# Public Comment for Planning Commission Special Meeting of November 17, 2022, Agenda Item 8b

## *From the Murphy Family at 1251 Claremont*

### Winter Noon Original Design March 2022 (No Daylight Plane)

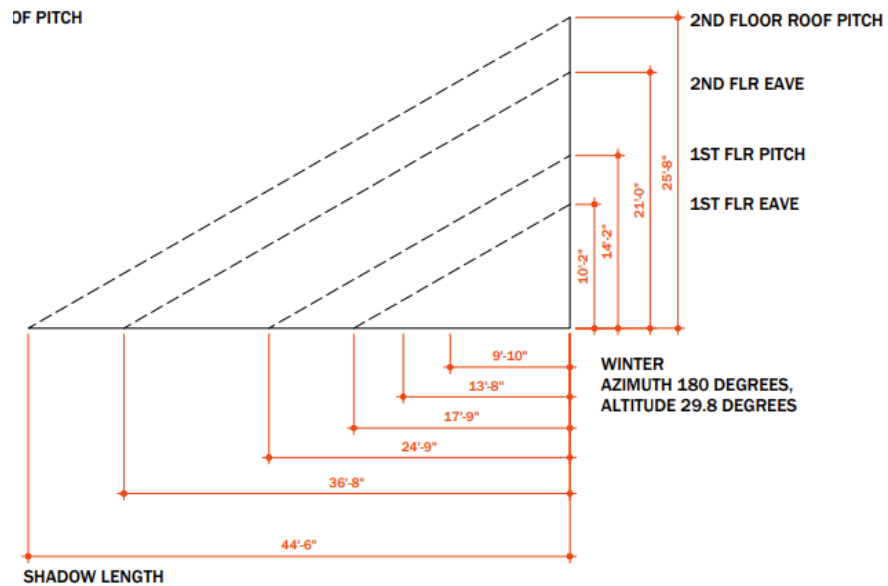
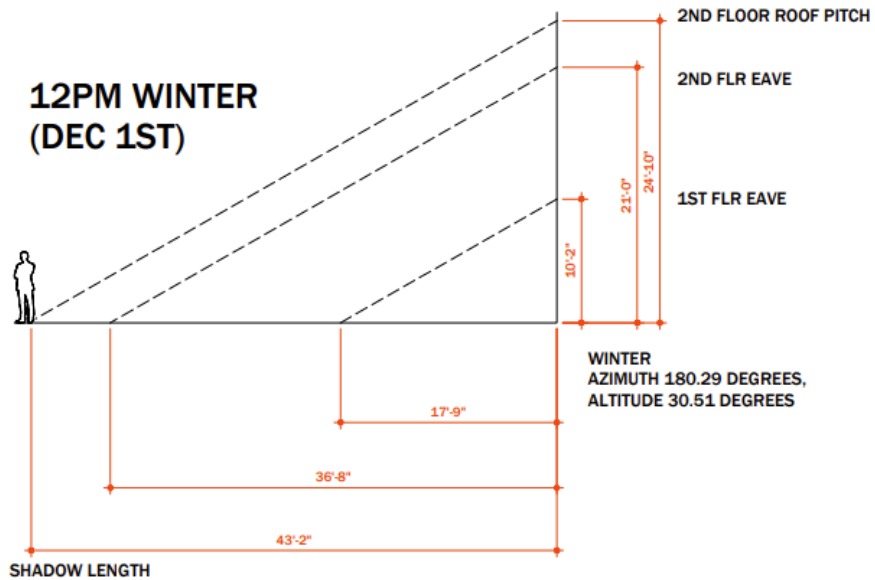
- **If you look two pages down** you will see two shadow length diagrams from winter 12pm, one for the March 2022 design (44’6”) with NO daylight plane implementation and one from the most recent design with the daylight plane implementation (43’2”). As you can see, there is only a difference of 16 inches or 3%. ***This is not an acceptable improvement and proves that the daylight plane implementation did NOT properly minimize the shading imposed by the March 2022 design, it is almost the same.***

The second-floor roof pitch shadow above is mitigated below by only 16 inches (3%), from 44'6" to 43'2"

**Original Design (17'3" from 2<sup>nd</sup> Floor Pitch to Property Line)**

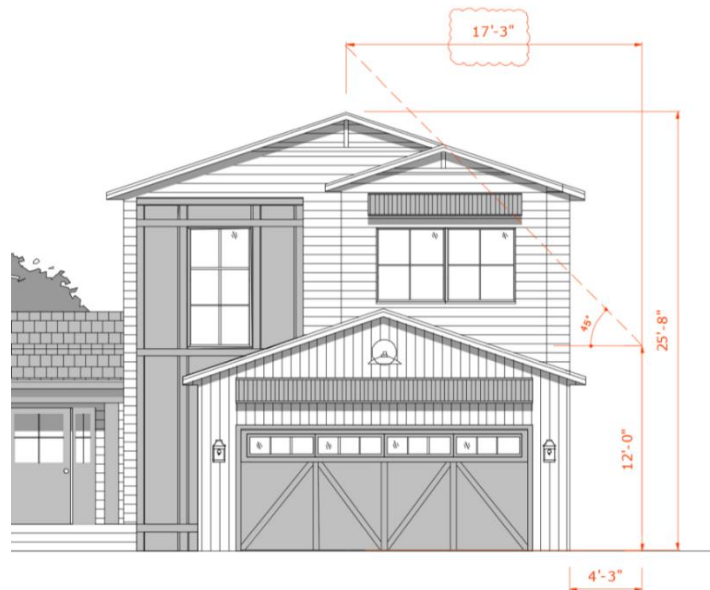
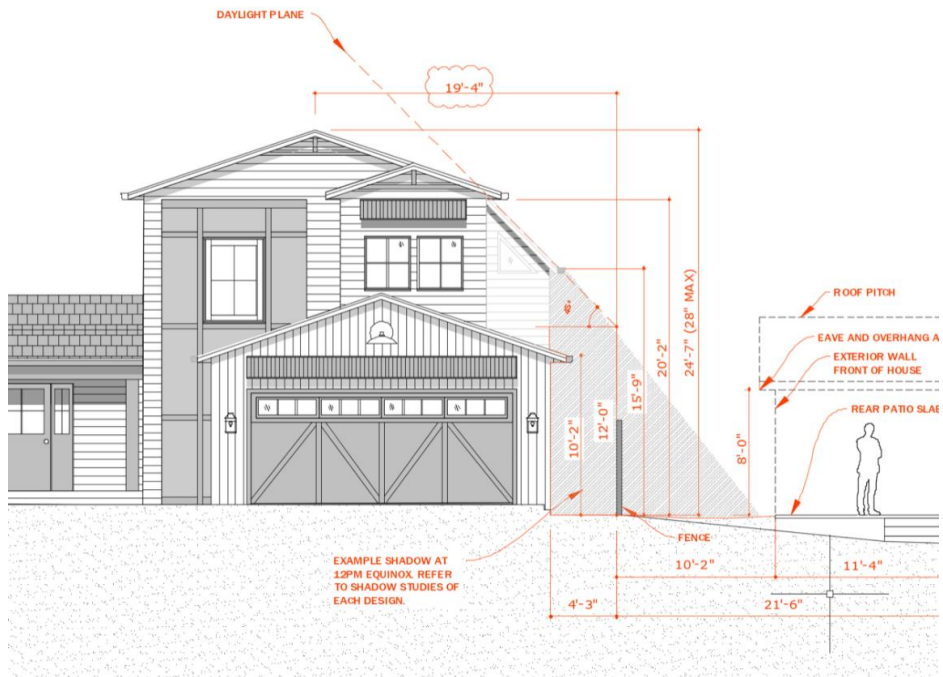
- **Why did the daylight plane implementation not minimize the shading?** The answer is that (1) the Lees property is already almost right on top of ours (for those who visited our property you were able to gain that perspective), (2) The height of the pitch is 24’7”, that and the close proximity to our property is the major cause of the shading and (3) the daylight plane implementation only moved the pitch away from the property line by 25 inches (**see three pages down for comparison graphic**) and so that pitch is still casting a major shadow

*The daylight plane implementation only moves the second-floor roof pitch over by 25 inches, which is why the shading mitigation is almost non-existent*

**Current Design (19'4" from 2<sup>nd</sup> Floor Pitch to Property Line)**
